CNSC staff update on elevated hydrogen equivalent concentration discovery events in the pressure tubes of reactors in extended operation

Commission Meeting

Review of Bruce Power Submissions on [H] and [D] Distributions in B6S13 and B3F16

P.J. Sedran, M.Eng, P. Eng.
Mech. Eng. Consultant

[D] Measurements versus Angular Position
For the Outlet PT RJ in B6S13 and B3F16

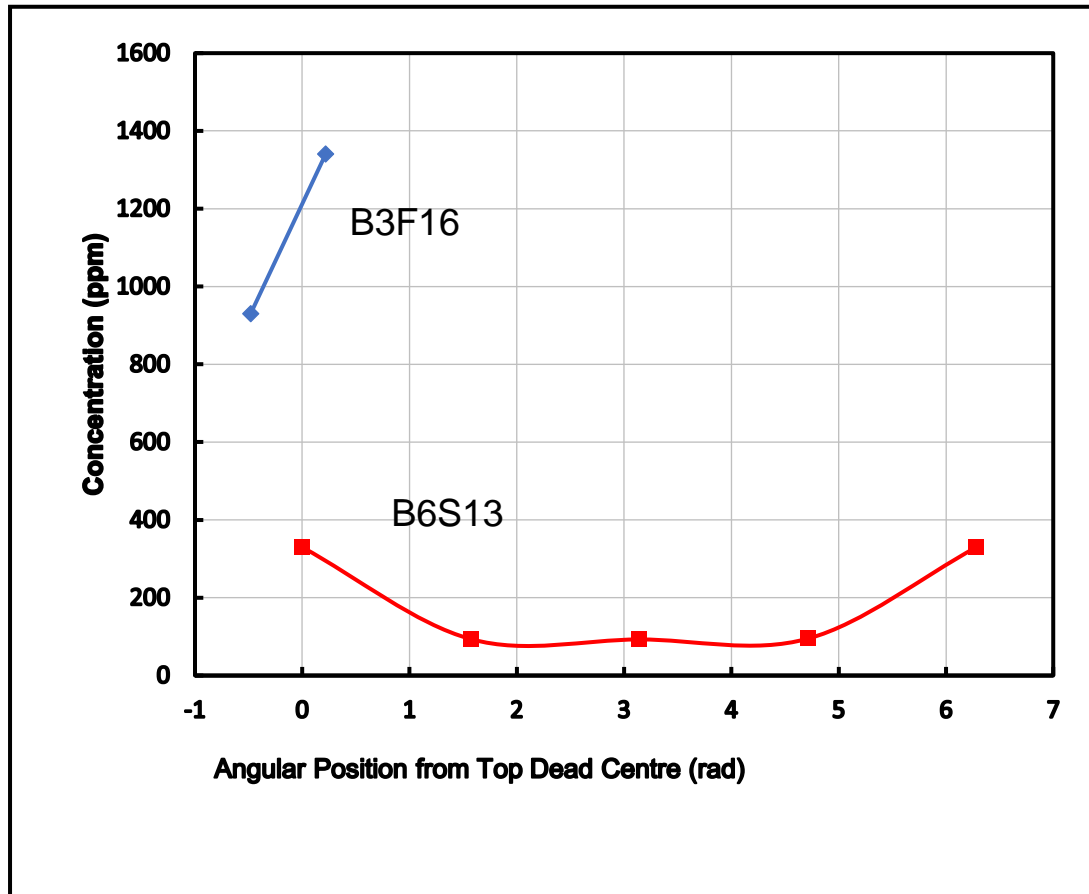
- Concentration Distributions are different
- B6S13 and B2F16 appear to act as individuals
- Implies an ingress mechanism with individual PT behaviour
- A significant radial concentration gradient in B6S13

Predicted T and T Gradient Required for the [D] Concentration Gradient Observed in the B6S13 Outlet RJ

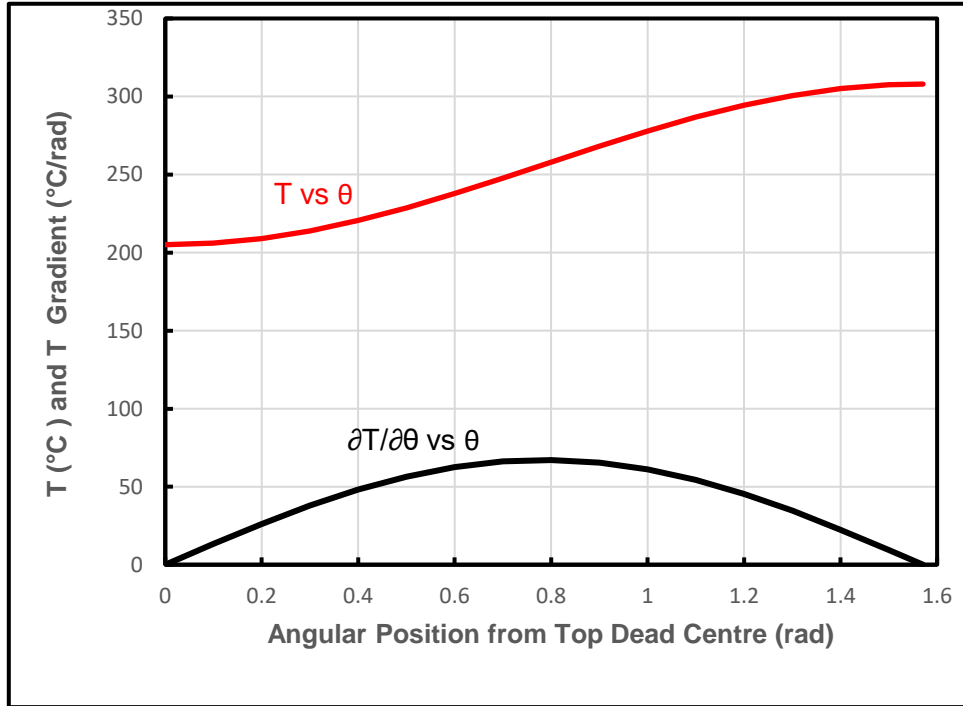
- Diffusion First Principles - $\partial T/\partial \theta$ causes $\partial C/\partial \theta$
- Thermal Diffusion Theory was tested by Predicting the Necessary Temperature Gradient
- Intuitively, a Temperature of 205 °C at the top of the PT seems too low

Expected Circumferential T & Predicted [D] Profiles For the B6S13 Outlet RJ versus Measured [D] Profile

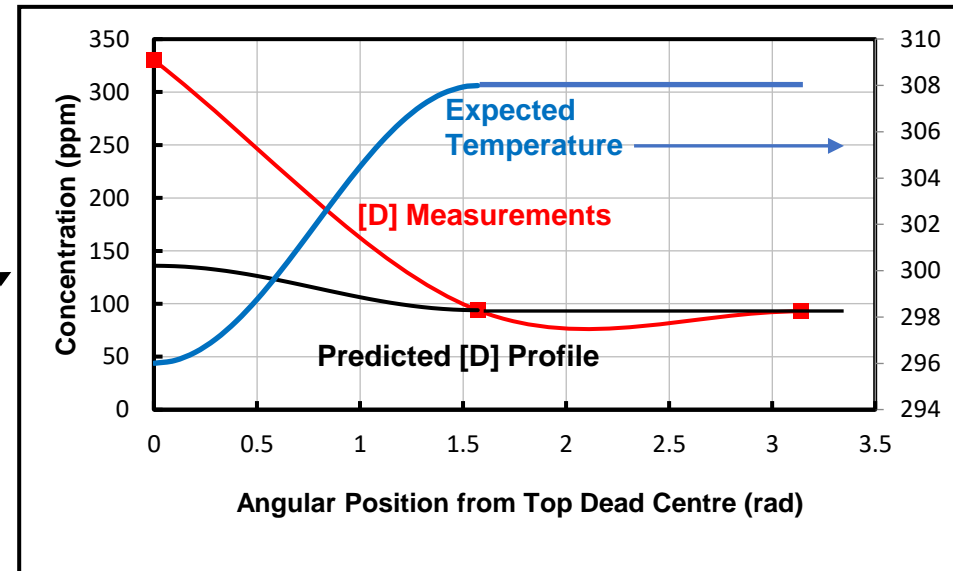
Measured [D] gradient is too steep to have been caused by the expected temperature profile
